SITE UTILITIES
BUILDING A & C AREA
SCALE 1"=20' DATE 2-20-67 JOB NO: 5386

SAN MATEO JUNIOR COLLEGE DISTRICT
SOUTH CAMPUS
REDWOOD CITY, CALIFORNIA

SU-2

ALTERNATE PLAN FOR AREA WITHOUT BLDG "J"

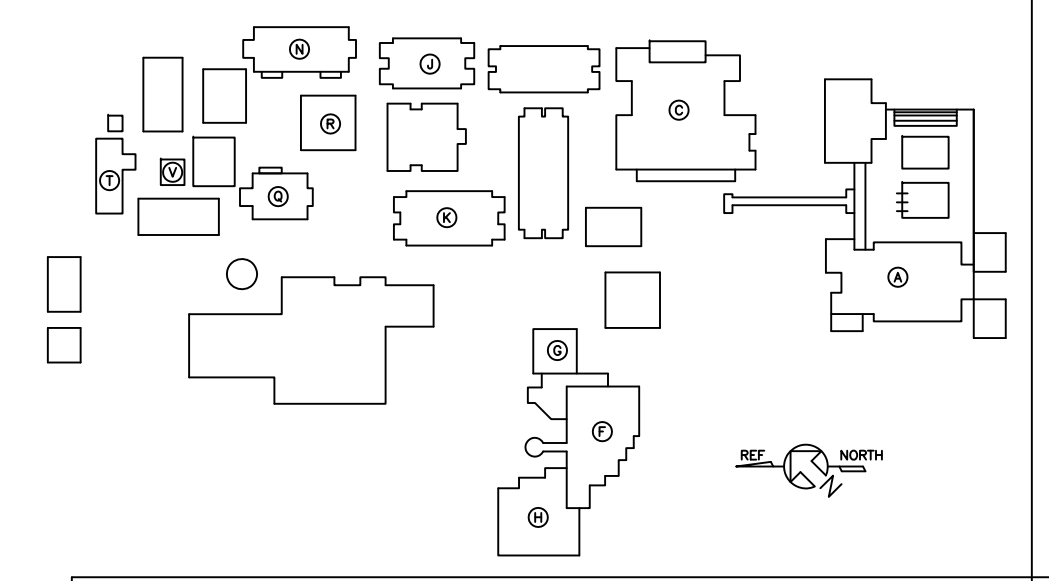
SEE SHEET SU-2 FOR STORM DRAINS IN THIS AREA THE ONLY CHANGE IN STORM DRAINS FOR THE ALTERNATE IS THE DELETE OF C.B.#85 AND THE PIPE FROM C3#184

PRIMARY TRENCH DETAIL
SCALE: 3/4" = 1'-0"

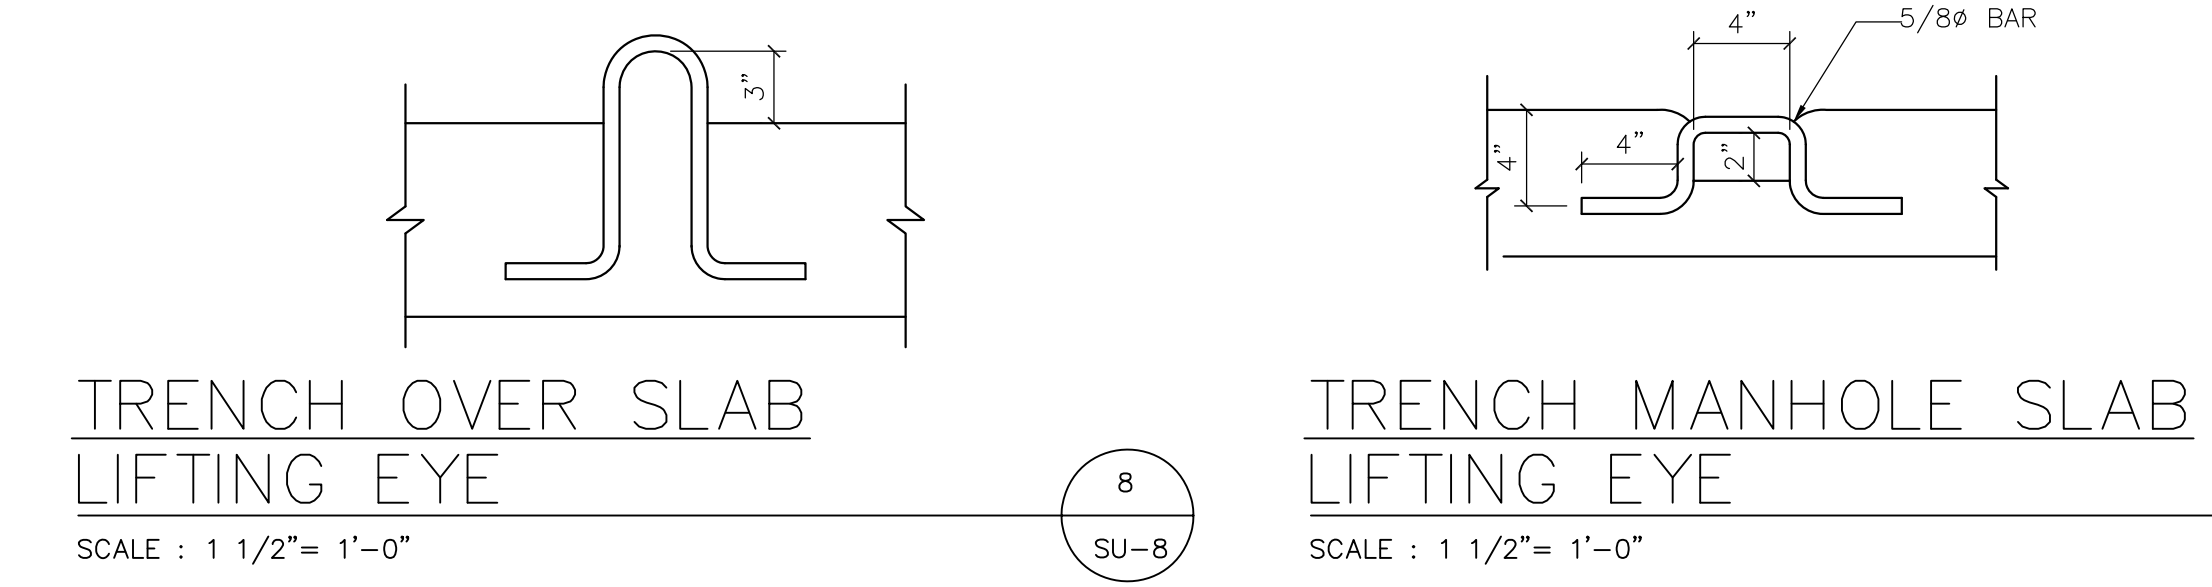
SHEET SU-8 (SITE DEVELOPMENT);
ADDENDUM DRAWING NO. 1002 REVISES PRIMARY TRENCH DETAIL AND TRENCH COVER DETAILS AND REVISES PRIMARY TRENCH.

SITE LIGHTING LANDSCAPE
 SCALE 1"=20' DATE 2-20-67 JOB NO: 5386

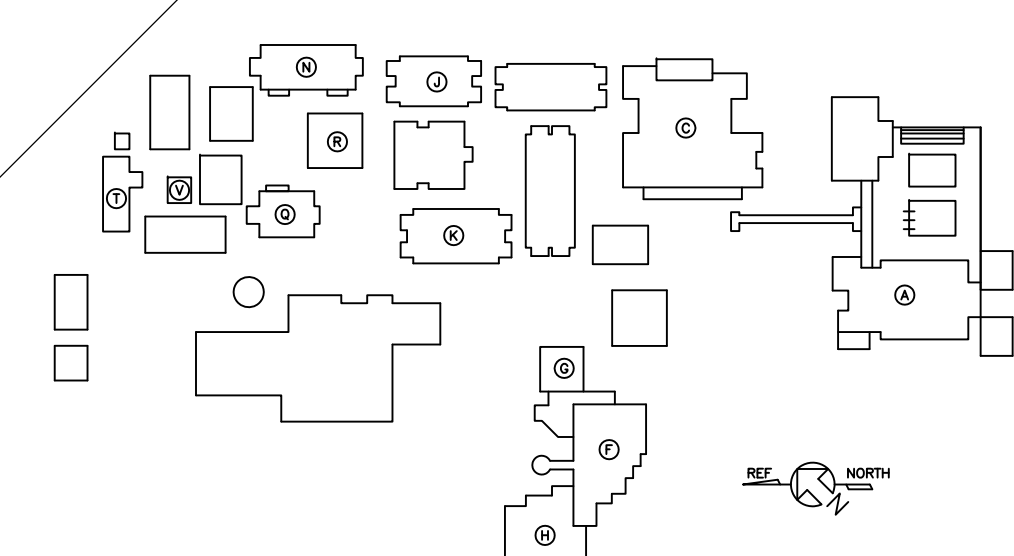
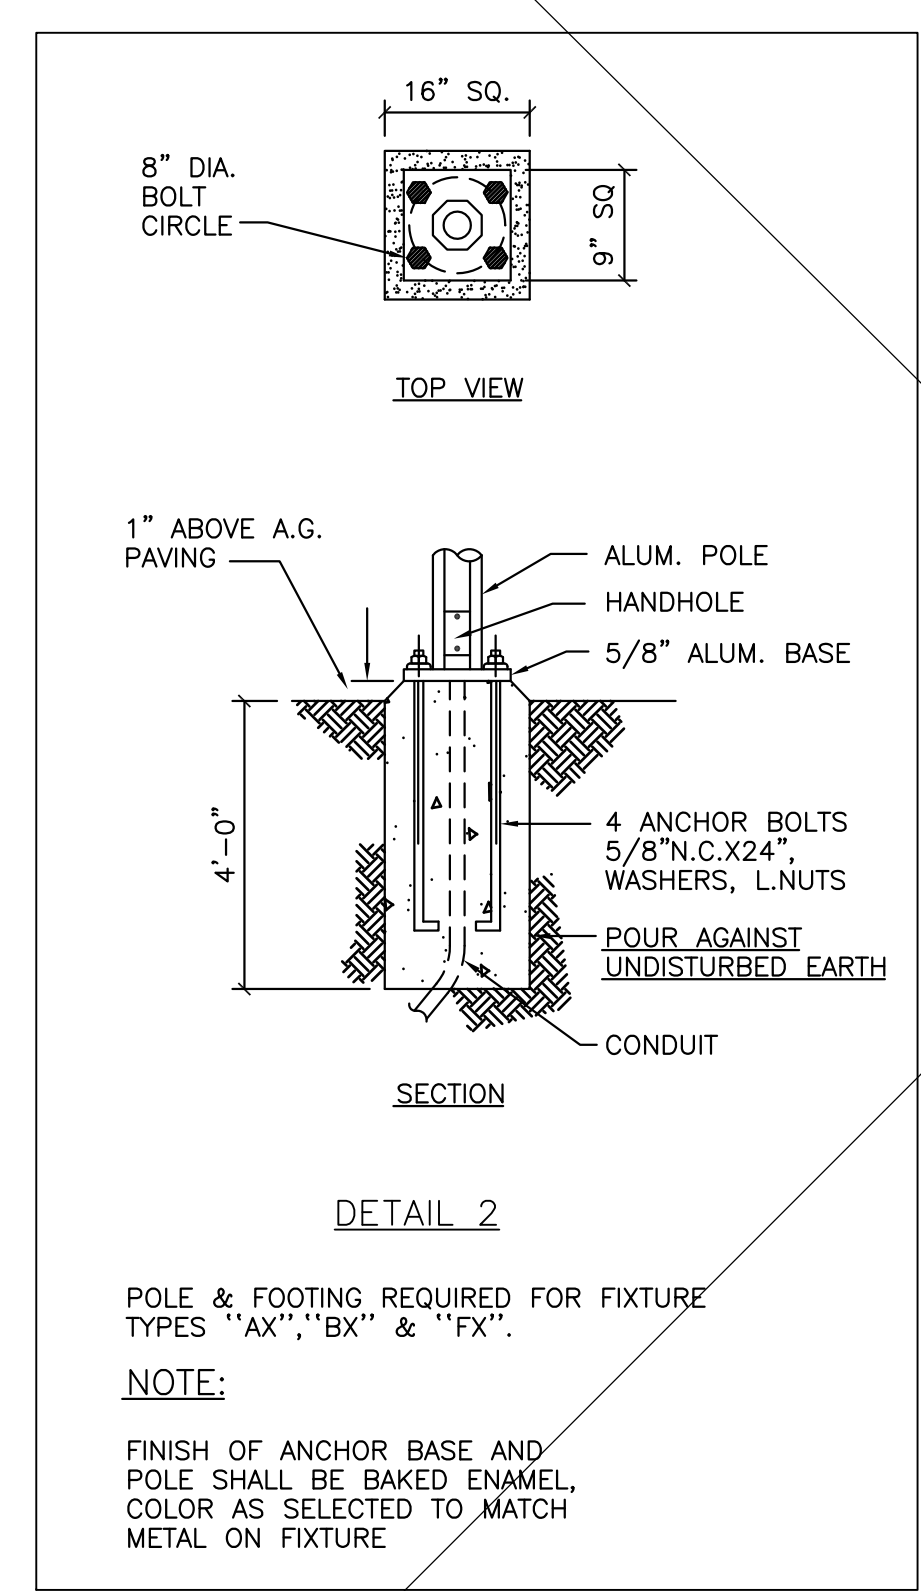
DRAWING SU-9
 DELETE ALL PARKING LOT FIXTURES AX (9 FIXTURES), CONDUITS, WIRES AND DEVICES (REFERENCE EAST OF BUILDING "C")

IRRIGATION PLAN
BUILDING A & C AREA

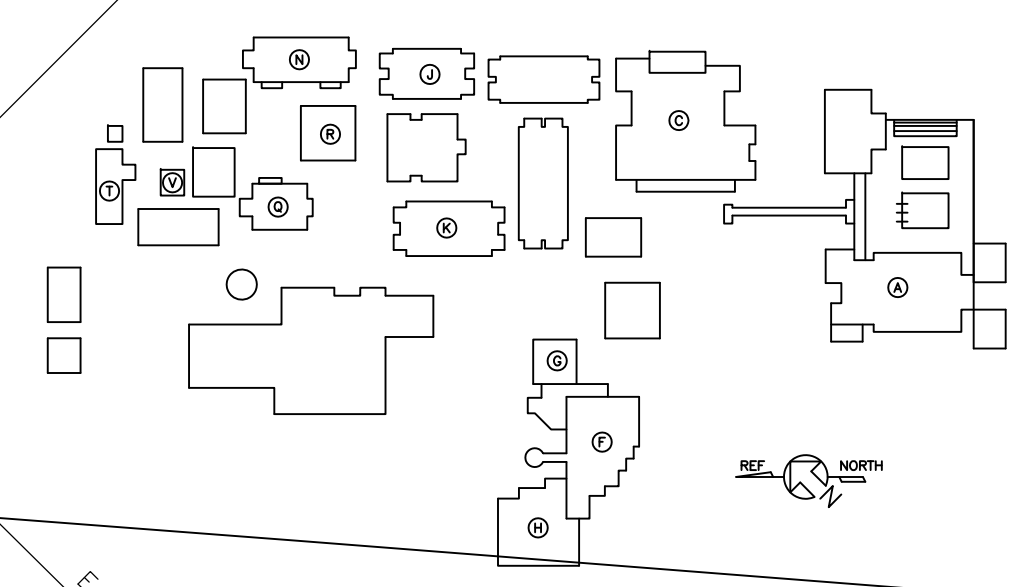
SHEET SU-12:
ADD THE FOLLOWING NOTES:
SYMBOL "□" INDICATES RC VALVE.
THE CONTROL BOXES SHALL BE LOCATED IN THE BOILER ROOM OF BUILDING C.
WIRES SHALL BE DIRECT BURIAL W/F 14-1 4/64 INSULATION FROM CONTROLLERS TO R.C. VALVES AND SHALL FOLLOW THE ROUTE OF THE MAIN LINE.
ALL SPRINKLER LINES SHALL BE PROTECTED BY BACK FLOW UNITS IN COMPLIANCE WITH THE LOCAL CODES.
DRAWINGS (ADDENDUM NO. 1):
ADDENDUM NO. 1, PAGE 16, SHEET SU-12, AFTER NOTE ON CONTROL BOXES, ADD THE FOLLOWING "CONTROL BOXES AND PANELS SHALL BE FOR CORE AREA AND CENTRAL MALL AREAS."
